**CITY OF CORNELIUS
COMMUNITY DEVELOPMENT DEPARTMENT**

**CALIDA MIXED-USE AND LAND PARTITION
Type III Site Design Review and Type II Preliminary Land Partition**

**Land Use File Nos. DR-81-22 & LP-01-22
Planning Commission Hearing Date: June 28, 2022
Staff Report Date: June 21, 2022**

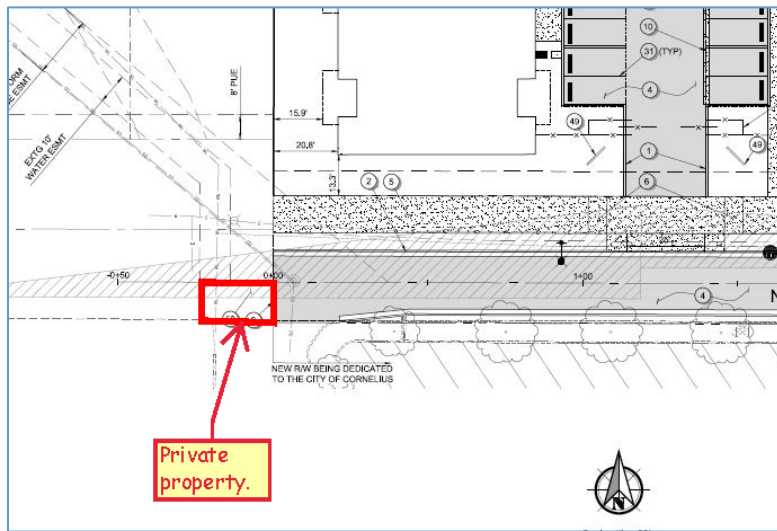
The portion of N. Davis Street adjacent to the Fred Meyer parking lot will be constructed as a ¾ street with curb/gutter on both sides, new 20-foot wide AC pavement, 6-foot parkway strip on the north side, and 12-foot multi-use path on the north and east side. The east-west section of N. Davis between and east of buildings 5 and 6 will be a full street with 12-foot multi-use path on the south side and 6-foot sidewalk on the north side.

The existing driveway on the east side of the Fred Meyer parking lot will continue to exist as a private street from N. Davis Street to the existing signalized intersection at Baseline St., southeast of Burger King.

The geometric configuration for N. Davis Street shown in the preliminary plans meets the city's Public Works Standards and is acceptable. The Baseline frontage is complete with curb/gutter and sidewalk, so no improvements in those areas are required by the City.

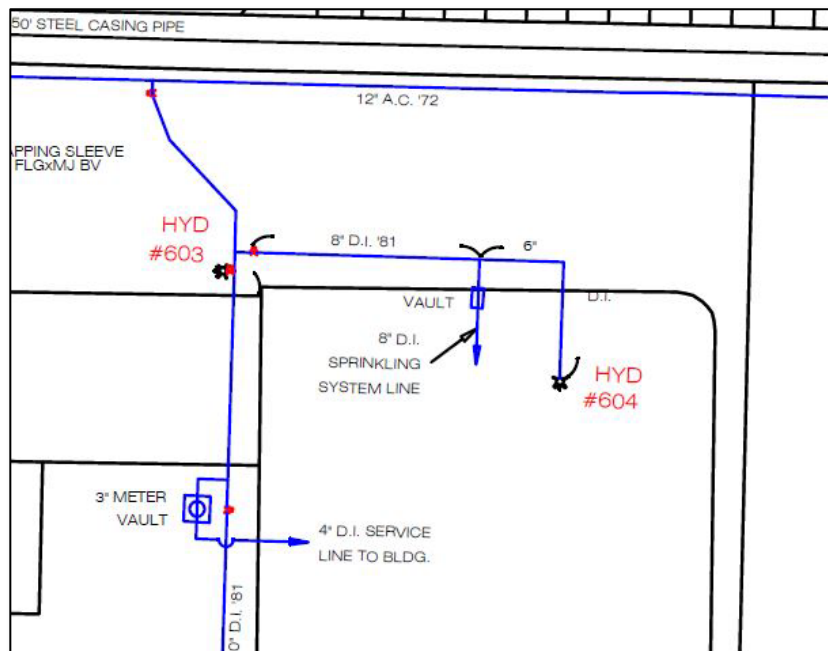
The preliminary plans do not show a connection for the existing hydrant (#604) and 8” sprinkler system line for the Fred Meyer site. These are now fed by an 8” DI water main that runs under the Fred Meyer driveway that will be replaced by the publicly dedicated N. Davis Street collector as shown in the drawing below.

The final engineering plans need to connect the proposed water mains in the Calida project with these existing public water mains on the Fred Meyer property.

Excerpt from Sheet A0.10 of the Applicant's submittal

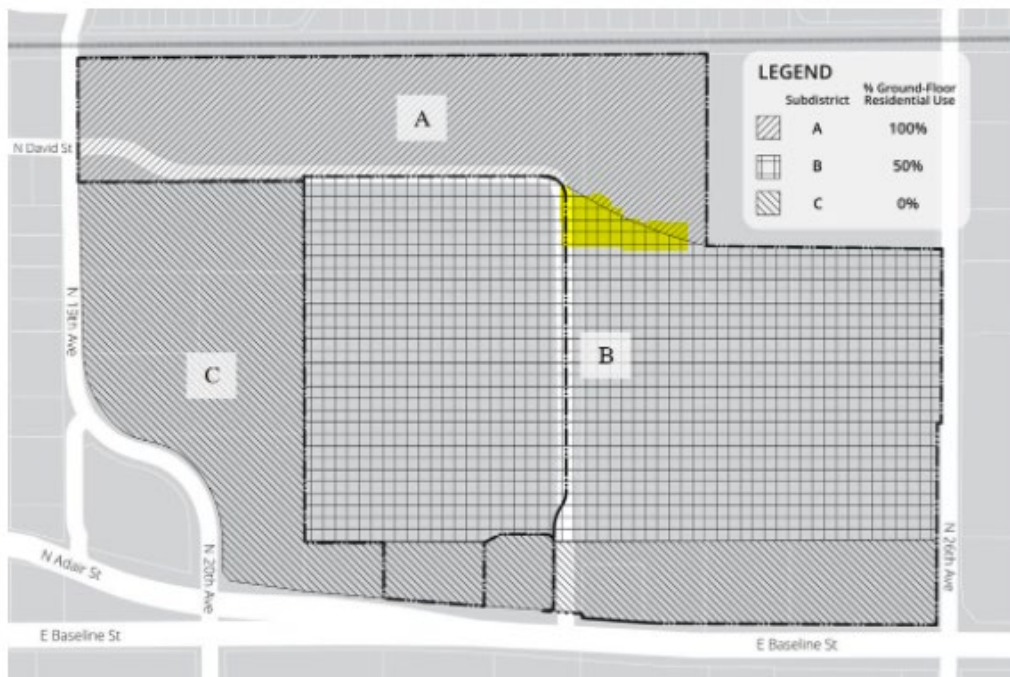
Findings: The ground-floor residential use buildings found within this project are within both Subdistrict A and B, permitting 50% ground-floor residential use in some areas 100% ground-floor residential use in others. The demarcation point between the two is shown by the Applicant on Sheet A0.10 of the plans set. Buildings 4-6 are within Subdistrict B, allowing 50% ground floor residential units, and Buildings 7-16 are within Subdistrict A, allowing 100% residential ground floor units. Since Subdistrict A allows for 100% residential ground floor units, calculations demonstrating compliance with this section are not required. Figure 1 below shows the Applicant's demarcation point, while Figure 2 shows the demarcation point found within the CMC.

Staff notes that Figure 18.75.065-1: GMU Subdistricts of the CMC depicts a demarcation point between Subdistrict A and B on the subject site that is slightly different from that which is shown by the Applicant. As shown in Figure 2 above, the highlighted area is within Subdistrict B, not Subdistrict A; however, staff concludes that the intention of the sloped demarcation point shown above is to follow the future alignment of N. Davis Street. The Applicant proposes a sharper turn for N. Davis Street as shown on Figure 1, which staff deems an acceptable alignment. For these reasons, the alignment proposed by the Applicant is deemed acceptable in that the difference in demarcation points is very minor and a new alignment of N. Davis Street was deemed acceptable by staff.

The total square footage of the area within Subdistrict B, as verified on Sheet A0.10 of the Applicant's plans set, is 230,426 square feet. The ground-floor residential areas equal 79,002 square feet or 34%, while the commercial ground floor areas of the live-work units and the leasing office measure 151,424 square feet or 66%; therefore, the Applicant proposes 34% of Subdistrict B. comprised of ground-floor residential uses and associated parking intended for residential uses.

Because Subdistrict B of the Gateway Mixed-Use zone is intended to be 50% ground-floor commercial, staff recommends a condition of approval to guarantee the perpetuation of the ground-floor commercial uses, such as a deed restriction on Parcel 2 of the proposed partition plat requiring a minimum of 50% ground floor commercial development. The Applicant may have an alternate proposal for review and approval by the Planning Commission guaranteeing a minimum of 50% commercial on Parcel 2.
